**DEVELOPMENT CONSENT AUTHORITY
DARWIN DIVISION**

AGENDA ITEM: **1** **MEETING DATE:** 07/03/2025 **FILE:** PA2024/0287

APPLICATION PURPOSE:	Communal space additions (verandah and enclosed gym area) to an existing dwelling-multiple with a reduced building setback to the side boundary
SUBJECT SITE:	Unit 8689, Common Property, Eley On Parap, (33) Parap Rd, Parap, Town of Darwin
ZONE:	MR (Medium Density)
SITE AREA:	1440m ²
APPLICANT	One Planning Consult Director - Israel-Tshepo Kgosiemang
PERSONS ON WHOSE BEHALF THE APPLICATION IS MADE	Landowner
LANDOWNER	Body Corporate for Eley On Parap Unit Title Scheme
ANY PERSON WITH AN AGREEMENT TO ACQUIRE AN INTEREST IN THE LAND	None

Figure 2: Proposed Site Plan

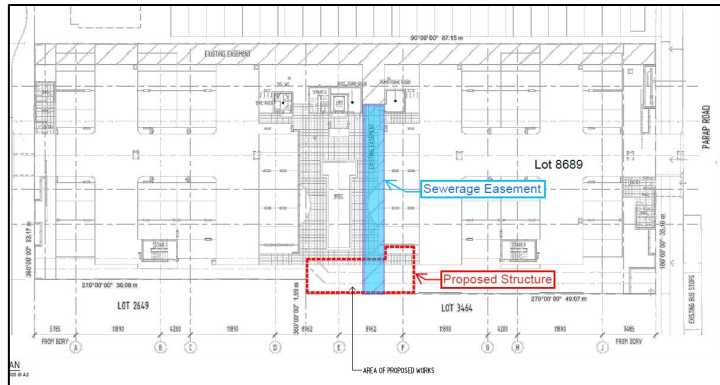
The application was placed on exhibition from 27 September 2024 to 11 October 2024. On 11 October 2024, Power and Water Corporation (PWC) - Water Services provided comments that Water Services object to the application as the proposed structure is encroaches over the existing sewerage easement. The application was deferred under delegation to address the concerns raised by the PWC- Water Services.

Figure 4: Amended Plan - 22/Jan/2025

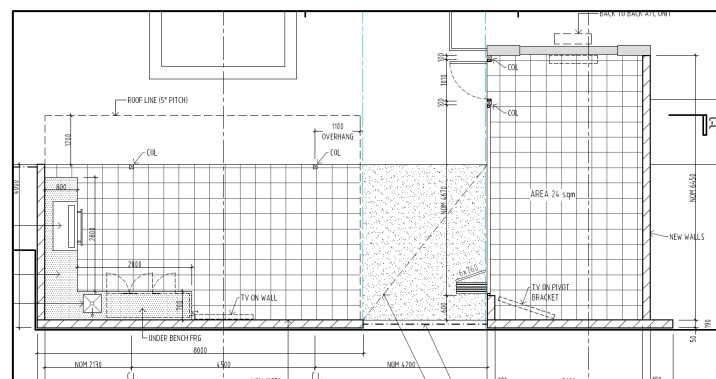
On January 22, 2025, the applicant submitted revised plans along with clearance from PWC – Water Services addressing the encroachment requirements. The amended plans depict the proposed structure as divided into two sections: a covered BBQ area on the western side of the easement and a gym area on the eastern side. A tiled area is situated within the easement. Refer figure 4 on the following page.

Figure 9: Proposed and Revised Plan (20/Feb/2025)

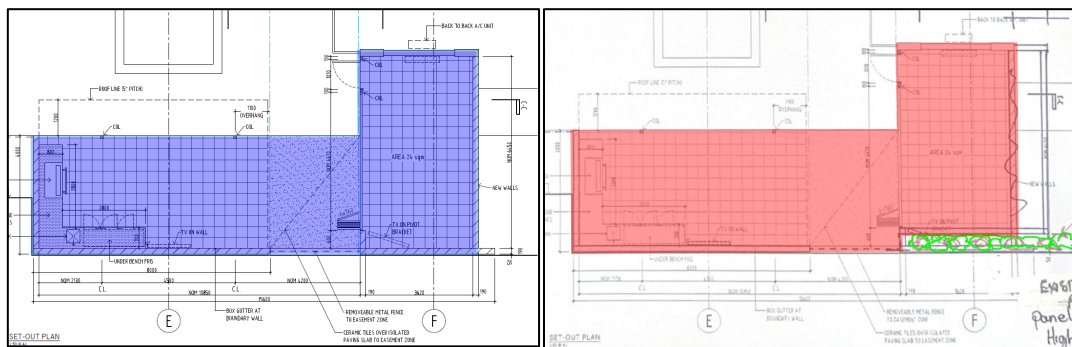
- The height of the proposed structure adjacent to Unit 7/31 Parap Road has been reduced from 3.8m to 3m to minimize the visual bulk impact.
- The eastern portion of the development has been recessed from the affected boundary, creating a 0.6m setback to Unit 7/31 Parap Road.
- A 0.6m landscaping buffer with potential growth up to 3m in height has been incorporated into the setback area to provide passive cooling and soften the view from Unit 7/31 Parap Road.
- The existing fence along the affected boundary will not be removed. All works will be conducted within the subject site.

The revised plan was sent to the public submitter, and a response was received by DAS on 24 February 2025 (**Bookmark F2**), stating the following:

- No solid fencing has been proposed; the existing fencing consists of a mix of cyclone mesh and 1.8-meter high panel fencing. Any removal or modification of the existing fence along the affected boundary would have a considerable impact on Unit 7 at 31 Parap
